11-13 COTTON STREET

February 17, 1954

SPECIFICATIONS FOR REMODELING  
9 - 11 COTTON STREET

November 18, 1948

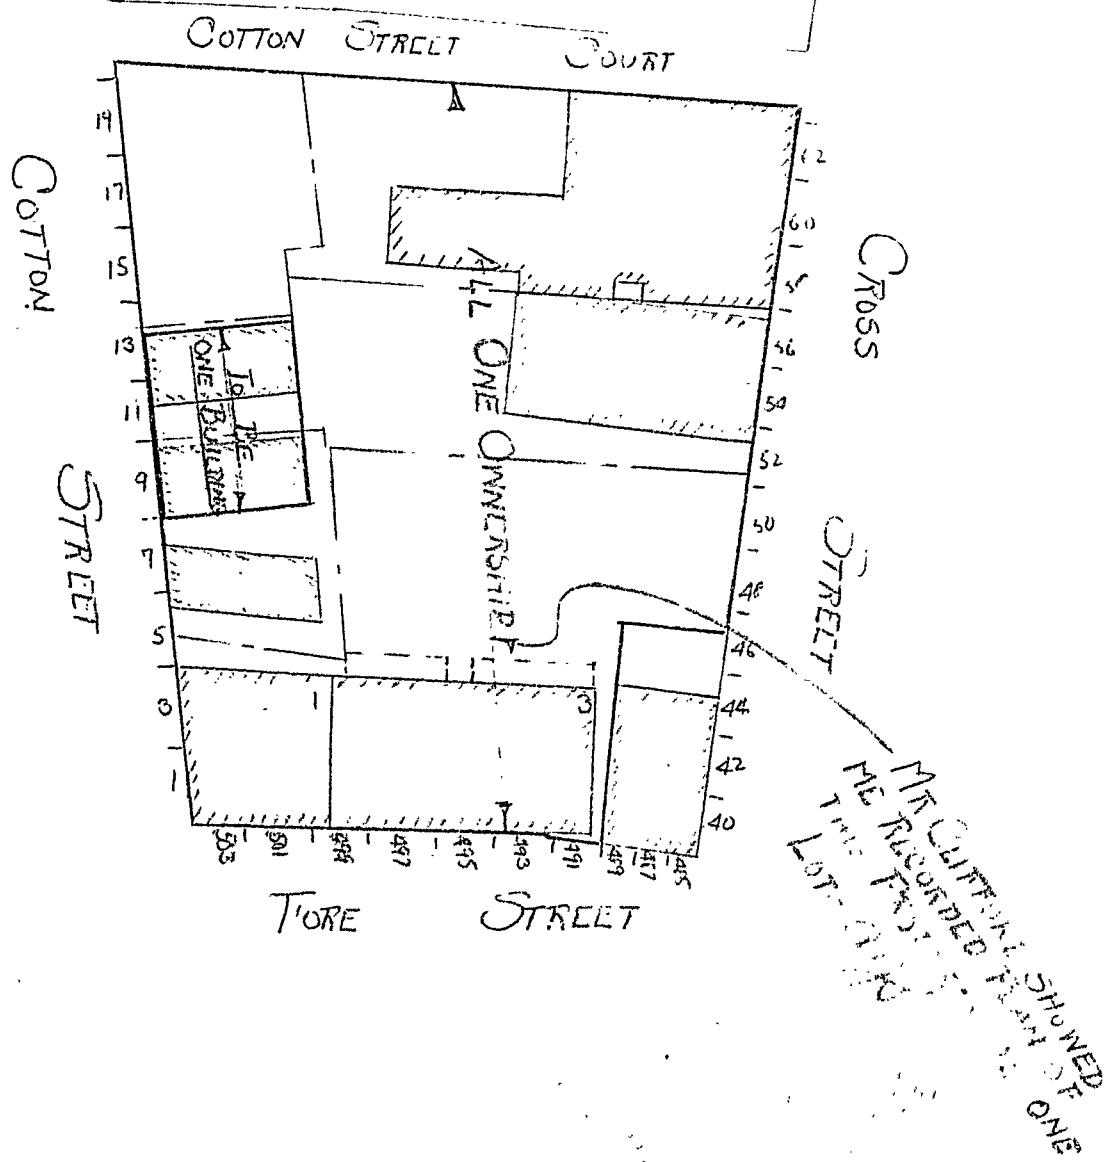
1. It is not clear what the thickness is of the existing masonry walls or how thick the new walls are to be. Lintels shown on the plan appear to indicate only an 8 inch thickness. The unsupported height of the walls as shown on the plan appears to be in excess of 12 feet. If this is to be the case, the use of 8 inch thick walls of this unsupported height is not allowable. - 12" walls

2. Although the surrounding property is apparently owned by your company, it appears to be subdivided into a number of separate lots for which definite lot lines are recorded. This being the case, it is necessary that any wall closer than 5 feet to one of these lot lines shall be extended upward as a parapet to a height of not less than 32 inches above the surface of the roof. Such condition will apparently be involved in the case of the rear wall and of that toward Cotton St. Court. - No lot lines for many years. Survey shows all one lot.

3. A statement of design (blank copy enclosed) is required for the design of the steel lintels over door and window openings. If the end of girder carrying roof timbers is to be supported over the lintel across the front entrance opening, size of lintel indicated for this opening may need to be increased. - OK

4. Framing plan of office floor is needed. While specifications call for the use of 2x8 joists, according to the plan they will be on about a 20 foot span, which is very much excessive for that size of timber. Office floor framing is required to provide a live load capacity of not less than 50 pounds per square foot. - See plan

5. Is there to be a cellare under the entire area now occupied by the building at 9 Cotton St. If so, part of the first floor area above will be outside the office space and will need to be framed to carry a live load of not less than 100 pounds per square foot. If not, a masonry wall will be required between the cellar and that portion to be filled in, and depth and thickness of such a wall needs to be indicated. - See plan

7. How are roof timbers to be supported on the masonry wall where parapet walls are not to be provided? Where parapet walls are required timbers will need to enter the walls, to have fire cuts on their ends, and to be provided with timber

anchors at least one and 1/2 by 3/8 by 16 inches long attached to the bottom of the joists. Where the timbers run parallel to the wall, the anchors are required to be long enough to engage three joists. All of this needs to be shown on the plan.

- #1. The Brick walls in present buildings are 12" thick to second floor level. Lintels are separated by 2" x 4" wood in order to fasten window casing on inside of window.
- #2. The lots in this section all belong to J. B. Brown & Sons and the company plans are to build commercial buildings in this section, disregarding any lot lines, as building will be built to suit tenants as size needed.
- #3. An error has been noted: a laly column is to be installed directly back of entrance door frame.
- # 4 & 5. Refer to plan with red markings.
- # 6. No. The doors are for loading and unloading.
- #7. All roof timbers in parapit to have fire cut and anchors not over 8 feet on centers. Size to be as specified.
